CASE NO. H-2024-0021
ORDER OF CONDITIONAL
APPROVAL OF FINAL PLAT

SUBJECT: Gander Creek South No. 4
FP-2024-0021

Final Plat consisting of 26 residential building lots and three (3) common lots on approximately 4.58 acres of land in the R-8 zoning district by Bailey Engineering.

B. Final Plat (dated: 08/30/24)

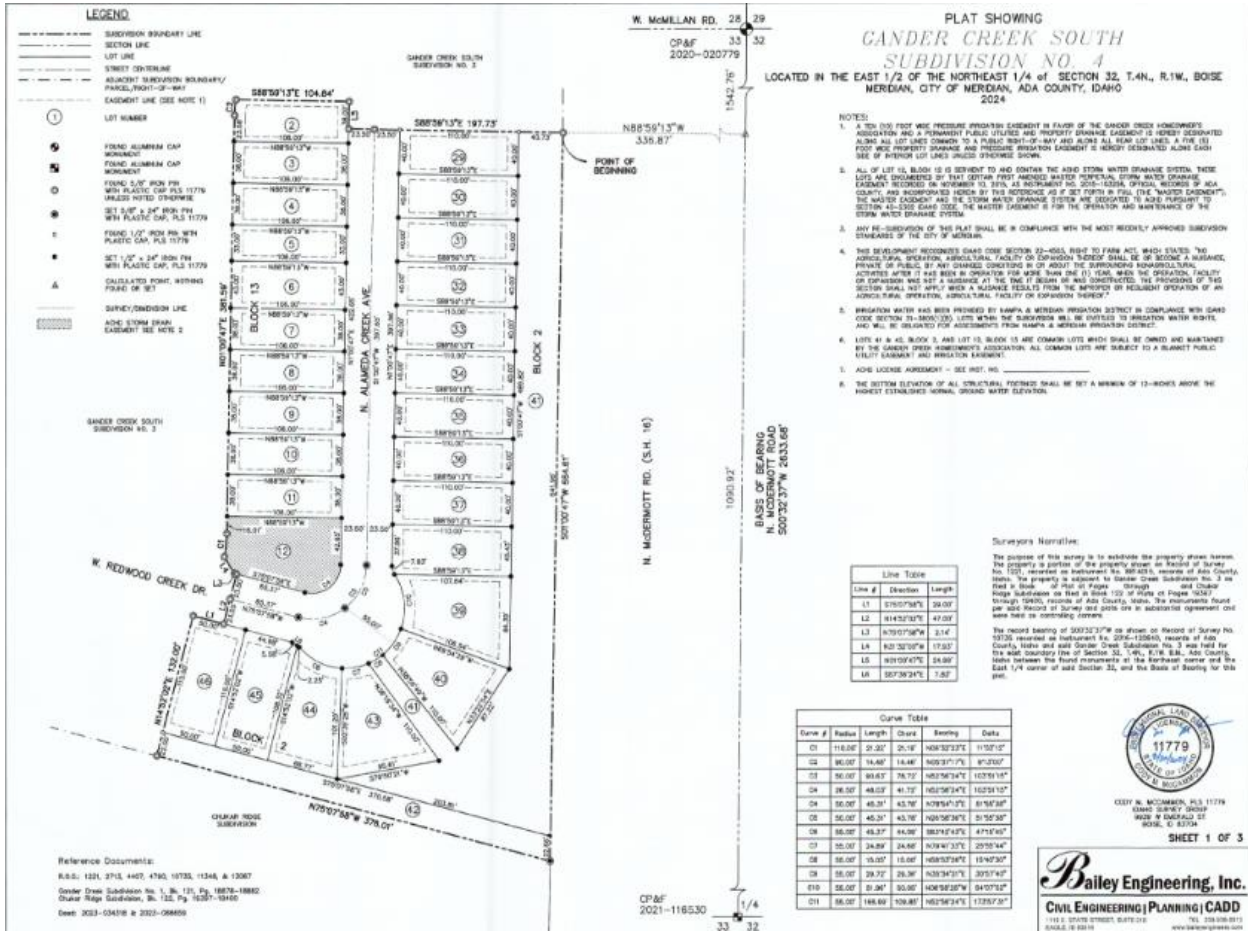
4. The final plat shown in Section V.B prepared by Bailey Engineering Inc., stamped on 08/20/2024 by Cody M. McCammon, shall be revised as follows:
 - a. Note #7: Include the recorded instrument number for the ACHD license agreement.
 - b. W. Redwood Creek Drive shall have an arrow showing the location on the plat.

An electronic copy of the revised plat shall be submitted prior to signature on the final plat by the City Engineer.

C. Landscape Plan (dated: 7/12/2024)

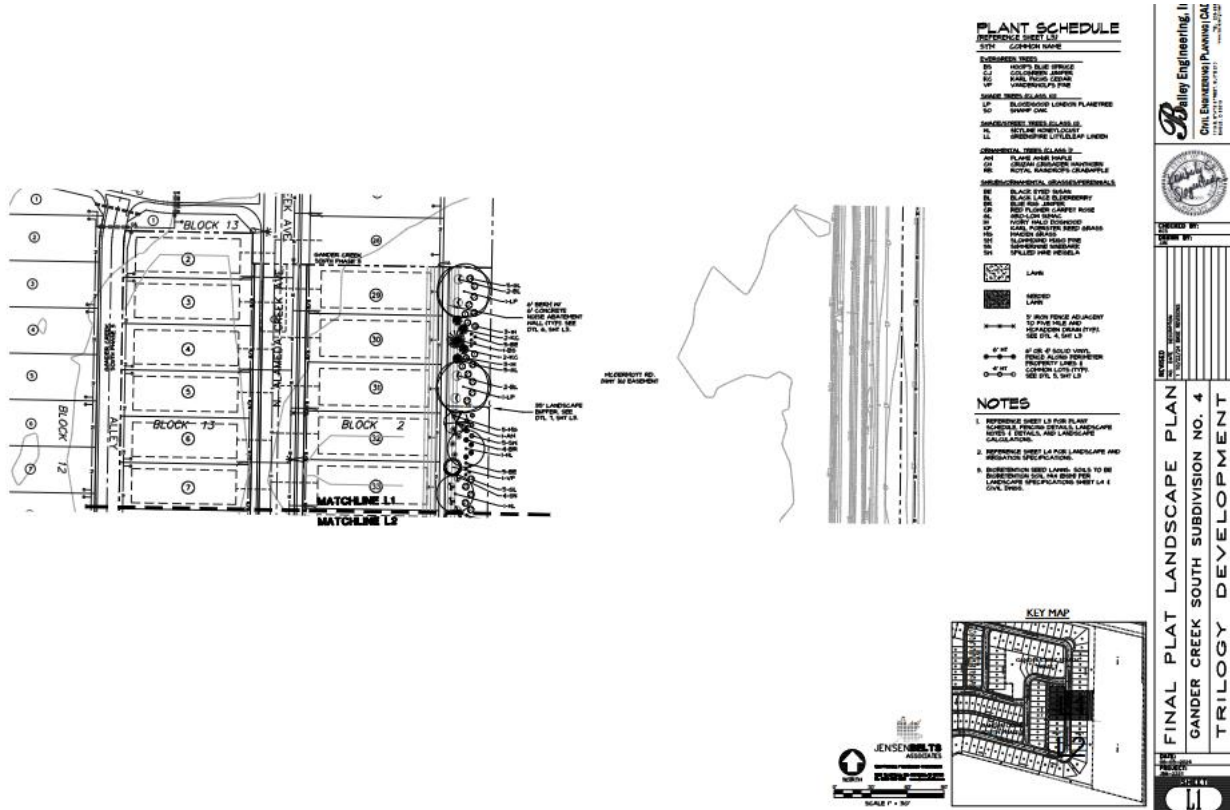
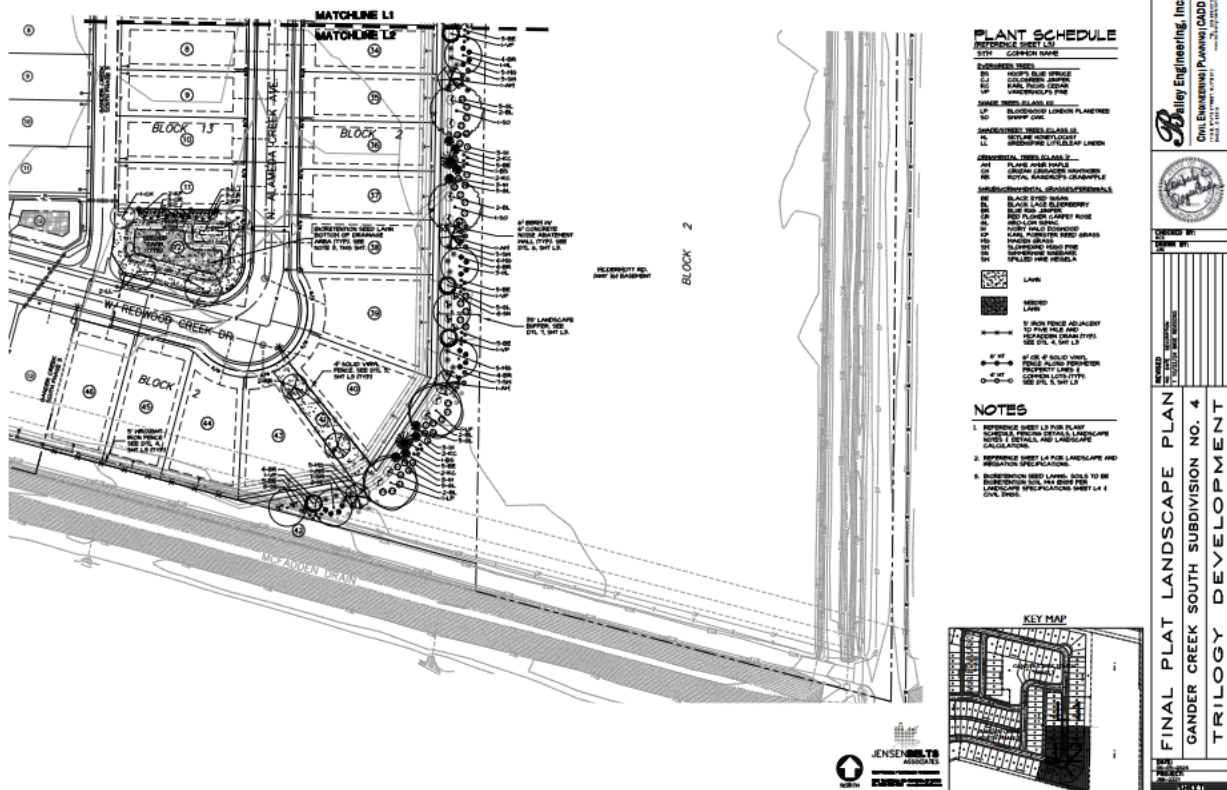
5. The landscape plan shown in Section V.C, dated 08/05/24, is approved as shown in Exhibit C.
 - a. A detail shall be included that depicts the centerline (or estimated centerline) of the future SH-16 in relation to the top of the berm/wall verifying it's a minimum of 12-feet higher than the elevation at the centerline of the state highway as required by UDC 11-3H-4D.2. The Director may approve alternative compliance as set forth in UDC 11-5B-5 where the Applicant has a substitute noise abatement proposal in accord with ITD standards and prepared by a qualified sound engineer as set forth in UDC 11-3H-4D.4.

- b. The 6-foot tall closed vision fence along the east boundary of the subdivision adjacent to N. McDermott Rd./future SH-16 shall be removed and either a use easement recorded across the back side of the berm along McDermott/SH-16 benefitting adjacent building lots with allowance for side yard fences to be constructed to the wall on top of the berm; or, an open vision, 4-foot tall closed vision, or 4-foot tall closed vision with 2 foot open vision fencing on top could be constructed for visibility of the common area between the fence and wall on top of the berm.
